Access Compliance Report

Public Rights-of-Way

(Curb Ramps)

Intersection ID: 18863	Main Street: DAMERON_ST	Cross Street: SELWYN_AV	Location:	E
ADA ID: 6520985C1C4A	Ramp Type: Perpendicular Diagonal	Initial Pass/Fail: Fail	Overall Compliance: No	Severity Score: 10
Codes/Mitigation Info/Possible Solution		Field Measurements/Component Compliance

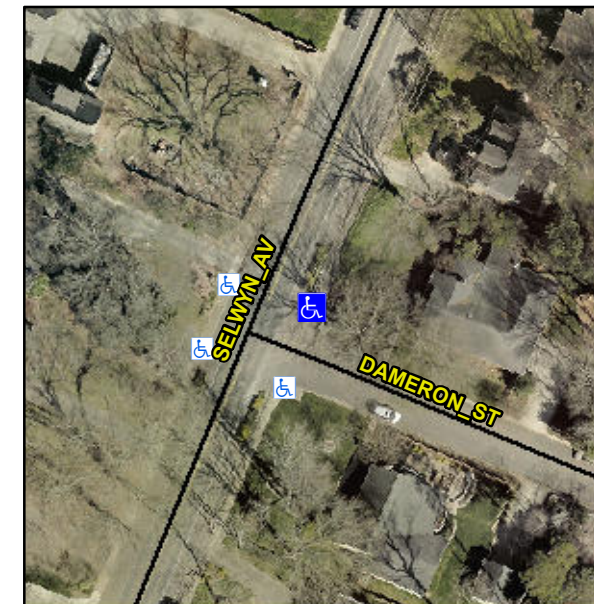
R304.5.1, R304.5.3

Compliance	Description	Data	Compliance	Description	Data
N/A	Ramp Length (in)	72.0	Yes	Ramp Slope (%)	7.6
No	Ramp Width (in)	41.0	No	Ramp XSlope (%)	3.5
N/A	Flare Type LT	N/A	N/A	Flare Type RT	N/A
N/A	Flare Slope LT (%)	N/A	N/A	Flare Slope RT (%)	N/A
N/A	Flare Traversable LT?	N/A	N/A	Flare Traversable RT?	N/A
N/A	Landing Length (in)	N/A	N/A	DWS Provided?	N/A
N/A	Landing Width (in)	N/A	N/A	DWS Contrast?	N/A
N/A	Landing Slope (%)	N/A	N/A	DWS Length (in)	N/A
N/A	Landing X Slope (%)	N/A	N/A	DWS Full Width?	N/A
N/A	Landing Curb? (Y/N)	N/A	N/A	DWS Offset (in)	N/A
N/A	Shared Landing?	N/A			
N/A	Gutter Ponding?	N/A	N/A	Gutter Slope (%)	N/A
N/A	Gutter Lip Ht (in)	N/A	N/A	Gutter X Slope (%)	N/A
N/A	Painted X Walk1?	No	N/A	Painted X Walk2?	No
	X Walk 1 Direction	To NW		X Walk 2 Direction	To SW
N/A	X Walk 1 Width (in)	N/A	N/A	X Walk 2 Width (in)	N/A
	X Walk 1 Slope (%)	2.0		X Walk 2 Slope (%)	1.8
	X Walk 1 X Slope (%)	2.1		X Walk 2 X Slope (%)	3.7

Remove & Replace Curb Ramp With Two New Directional Ramps or Equivalent.
